ADDENDUM #3

PROJECT: Rapid Valley Elementary School Addition and Remodel
DATE: March 16, 2026
BID DATE: March 19, 2026 at 2:00pm MST

PROJECT ADDENDUM NO. 03

ADDENDUM NO. 3 - MECHANICAL

1 CANOPY ROOF FRAMING PLAN - WEST
SCALE: 1/4" = 1'-0" REFERENCED FROM: 1/S111

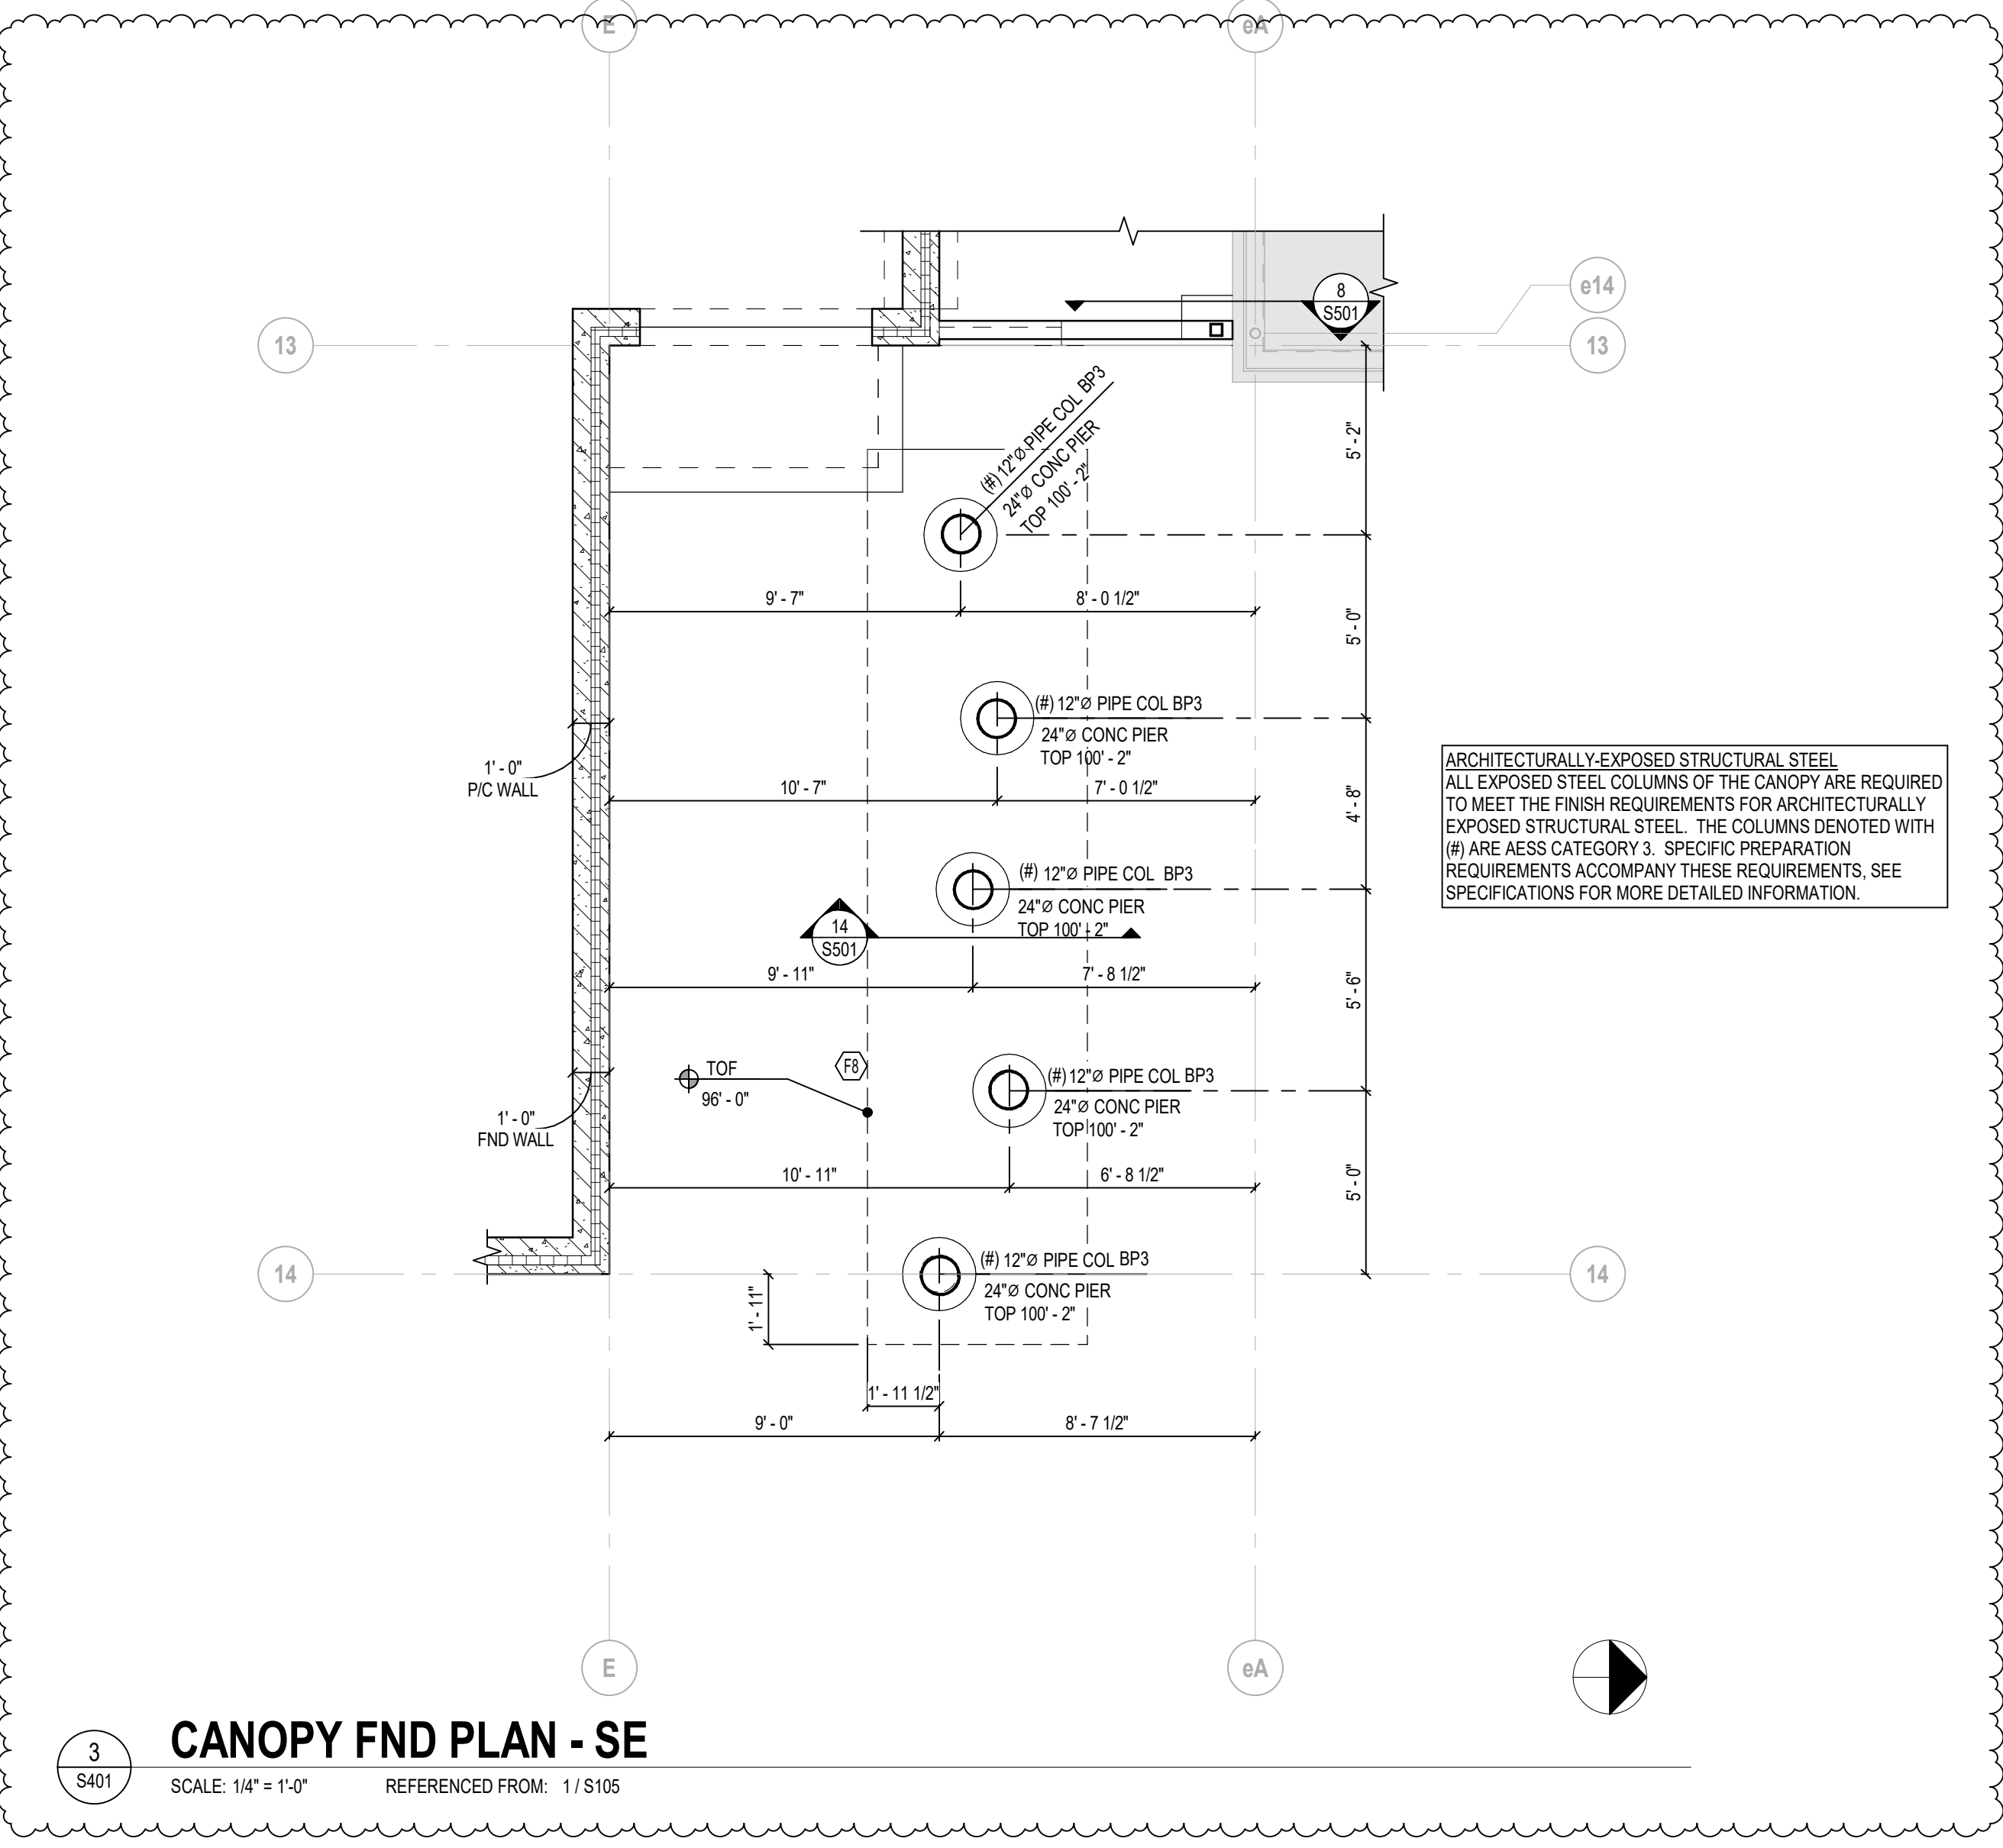
- ◆ SHEET S401
 - i. Canopy Roof Framing Plan – West, steel roof decking note was added.
 - ii. Canopy Fnd Plan – SE, square concrete piers were revised to be round piers.
- ◆ SHEET S501
 - i. Detail 14 was updated for the round piers.
 - ii. Detail 13 & 14 – Note added to chamfer top edge of pier.
